**City of
Richmond**

Report to Development Permit Panel
Planning and Development Department

To: Development Permit Panel
From: Brian J. Jackson, MCIP
Director of Development
Date: February 8, 2012
File: DP 10-556907
Re: **Application by KENNETH E. KING Architecture + Planning for a Development Permit at 6311, 6331, 6351, 6371 No. 4 Road**

PLAN 12

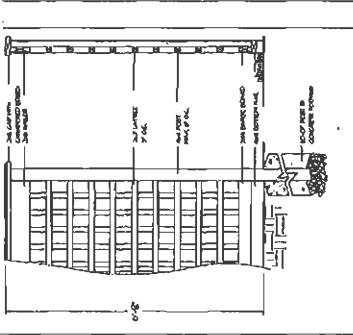
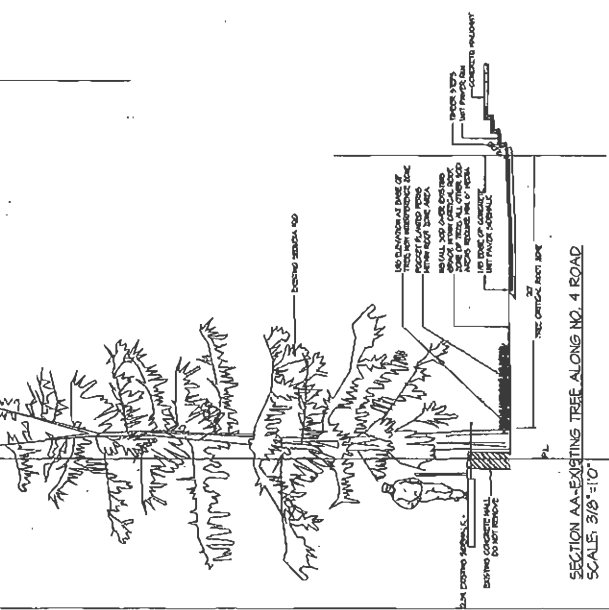
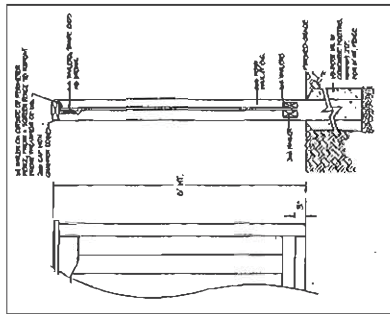
- 2) Reduce the north side yard setback from 3.0 meters to 0.0 meters to locate a screened recycling/garbage enclosure there;

(Staff supports the proposed variance because it is associated with a low free standing enclosure located within the required interior side yard. Please see Plans 7, 11, and 12 for details of the lattice enclosure. The enclosure is 1.85m [approximately 6 feet] in height. A 1.85m [approximately 6 feet] solid wood fence separates the garbage enclosure from the access ROW on the neighbouring property. This will facilitate efficient collection on-site with no collection truck stopping on No. 4 Road.)
